DATE: June 10, 2016 **RFI No.** 012

PROJECT: **Waitsfield BRF 013-4(39) - Bridge No. 177**
VT Route 100 over Mad River

RE: RFI #12: Abutment #2: Stem Wall PC5, Tack Welding Rebar

1 REINFORCING PLAN VIEW IN FORM

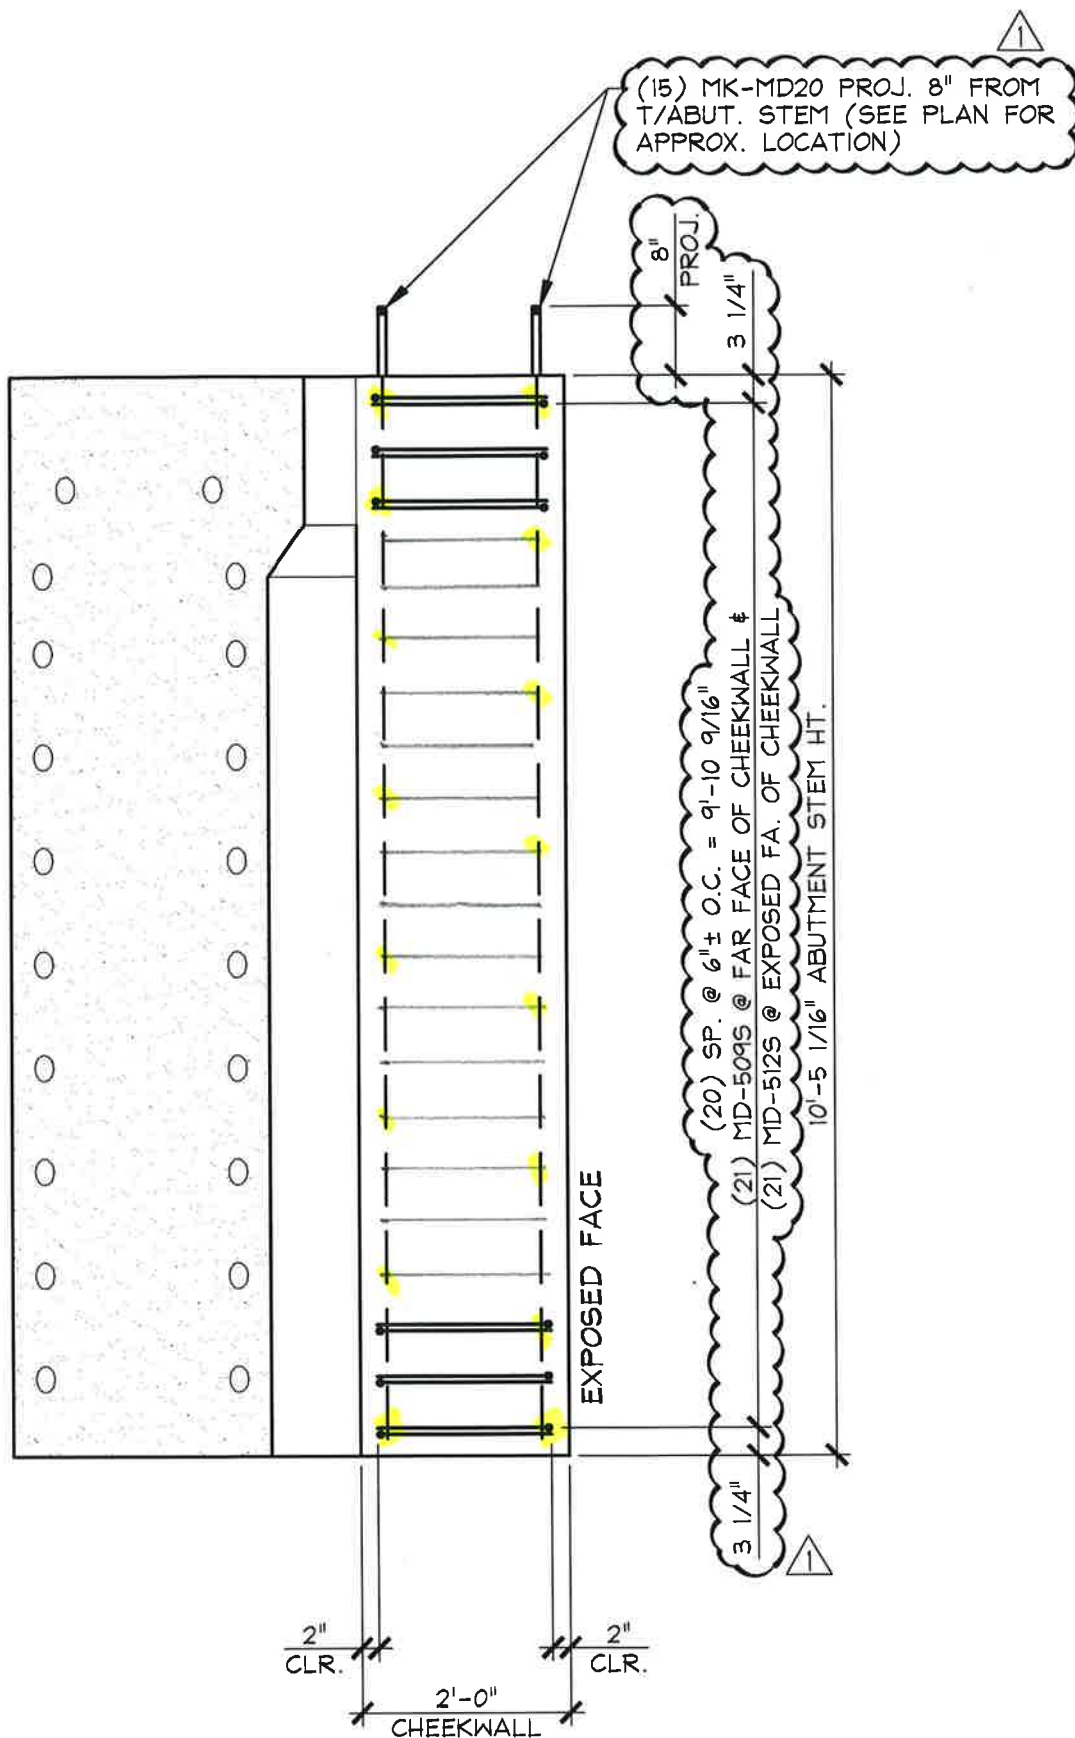
1. **Question:** JPC requests permission to tack weld reinforcing rebar in the wing portion of the Unit PC5 at the highlighted intersections on the attached details.

JPC requests permission to tack weld reinforcing rebar in the wing portion of the unit PC5 at the highlighted intersections on the attached details.

Response: MJ has reviewed the issue, and as discussed with JPC (6/10/2016), RFI #12 is rescinded and the reinforcing bars shall not be tack welded. The reinforcing bars noted in the RFI will be tied.
